STAFF REPORT

PLANNING BOARD MEETING

- Case #38-16:** SITE PLAN REVIEW
Case #39-16: SPECIAL PERMIT FOR PARKING REDUCTION
Case #40-16: SITE PLAN REVIEW FOR NEW GROUND SIGN
SW Corner of Swift & Orchard Streets
Map 23, Lot 292

The submittal is named on the Title Sheet as Proposed Family Dollar Retail Store, Orchard Street, New Bedford, MA Issued for Special Permit, dated November 4, 2016, prepared for Hunt Realty Real Estate Services, Inc., 5100 W Kennedy Blvd, Ste. 100, Tampa, FL 33609, by Prime Engineering, P.O. Box 1088, 350 Bedford Street, Lakeville, MA 02347 consisting of ten (10) sheets.

SHEET NO. **C1.0**

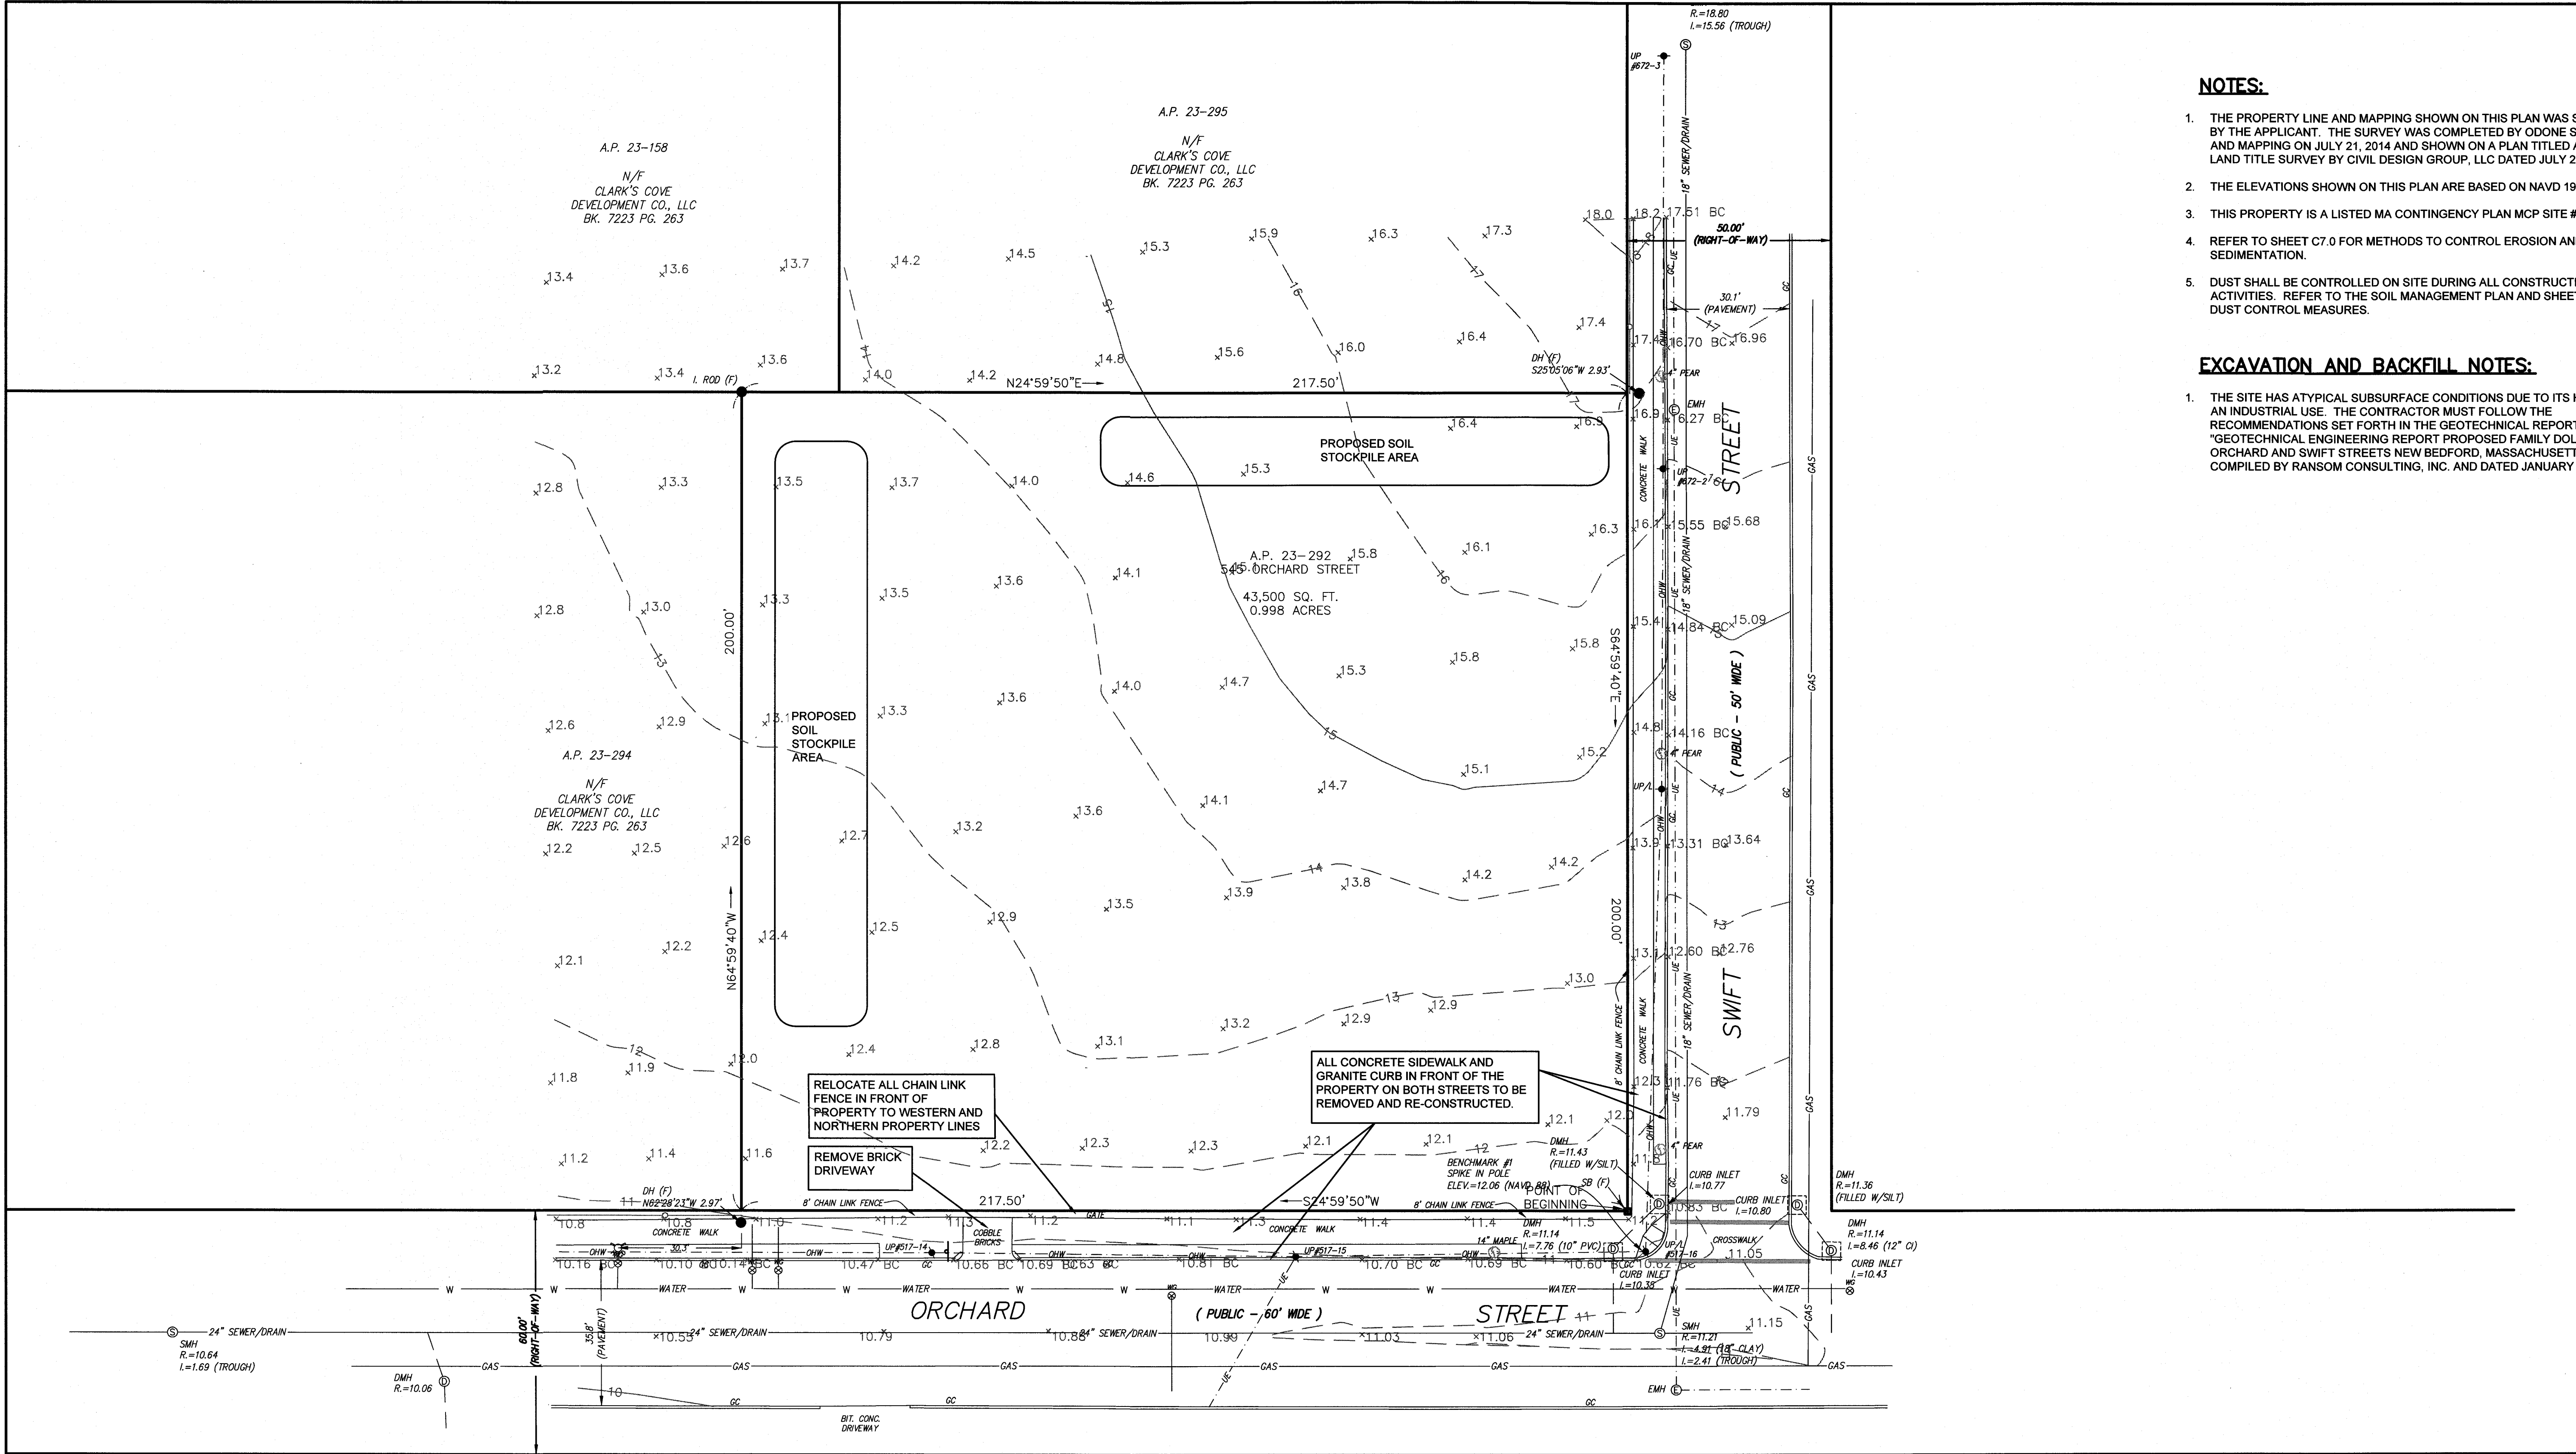
- The Site Plan Review Application asks the following “Benchmark locations (Based on USGS NGVD – show year)”; this request for waiver does not apply to the Planning Division checklist, therefore the petition by applicant is unnecessary.

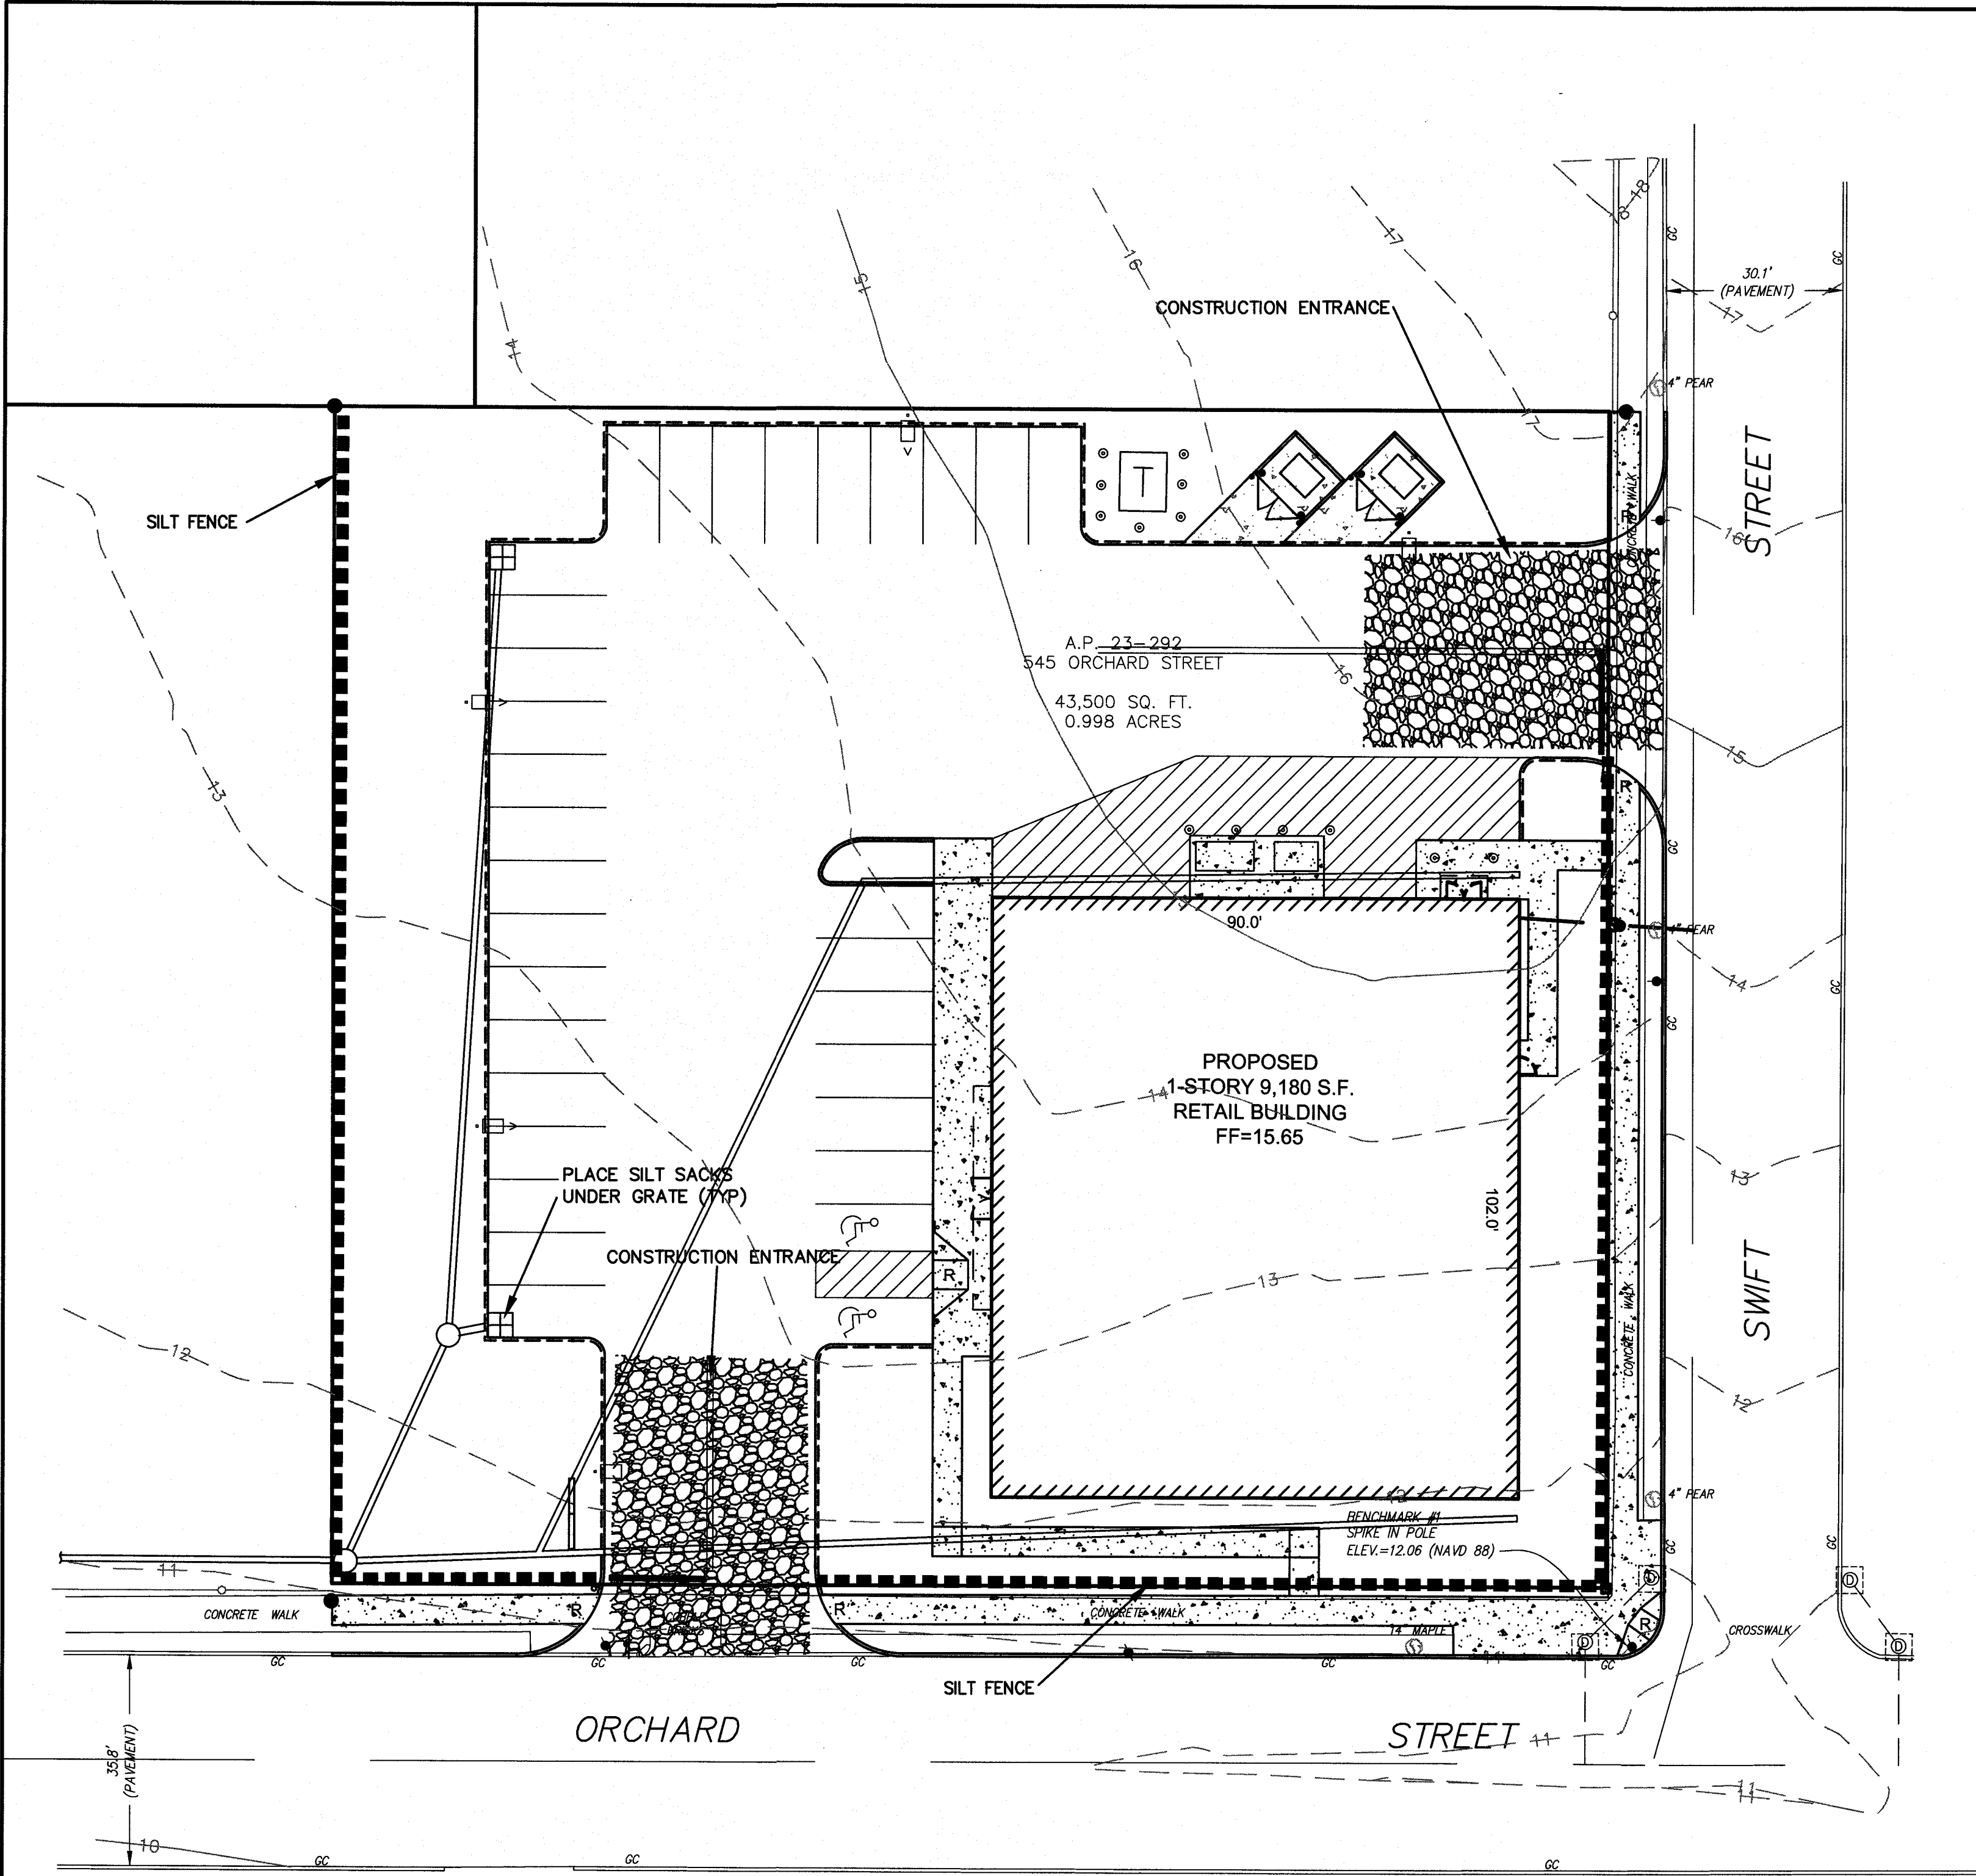
- Applicant is to seek approval with the Department of Public Infrastructure for proposed two (2) lilac trees and eight (8) additional large trees as Noted.
- There are discrepancies between plant schedule and number of plantings shown as noted. Applicant shall review plans and make corrections.

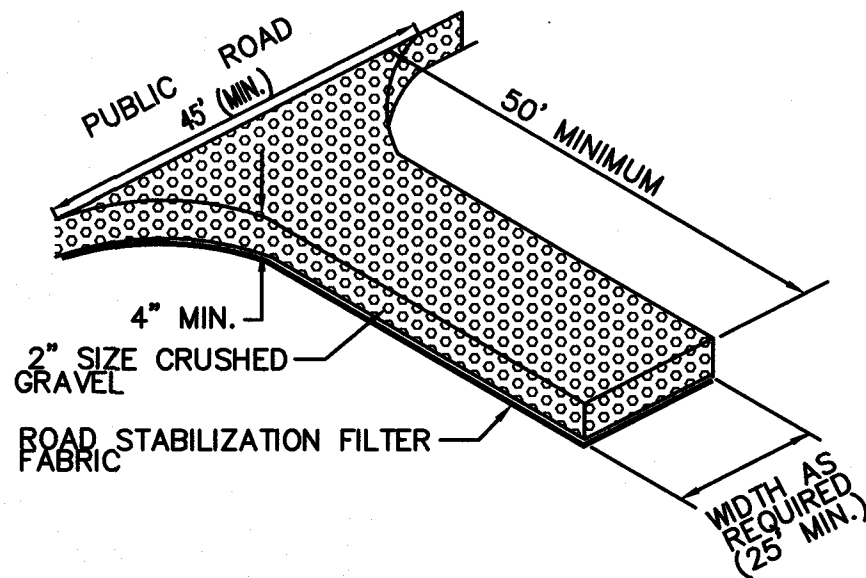
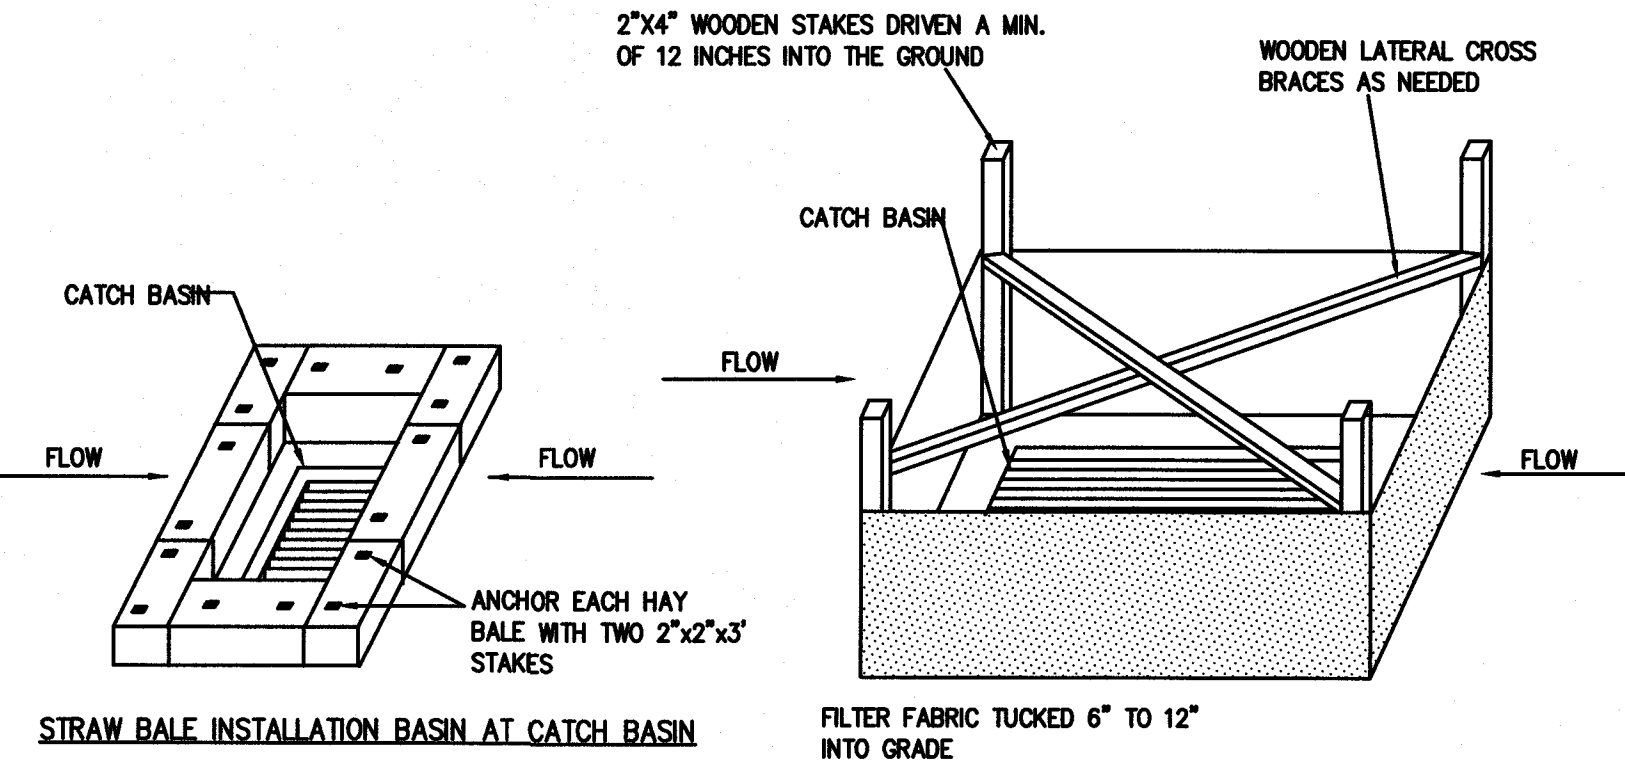
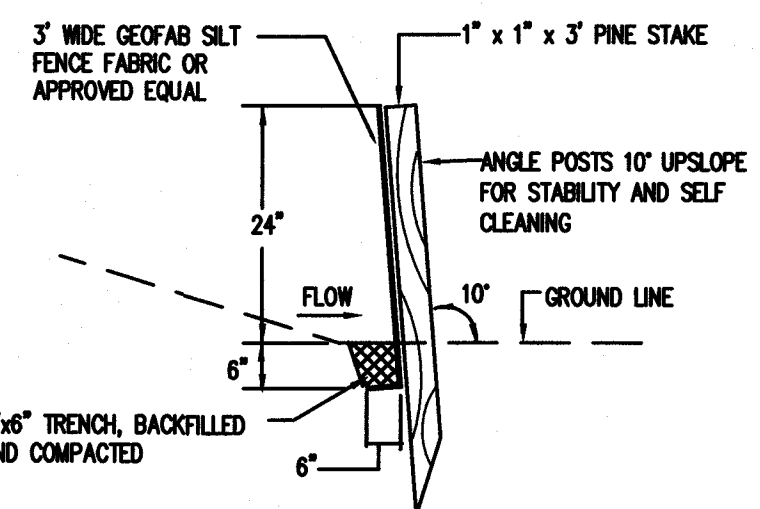
- Replace “Hay” & “Haybale” with “Straw”.
- Note: All references to Hay shall be replaced with Straw in the Stormwater Report, and all other case submittal documents as prepared by the applicant.
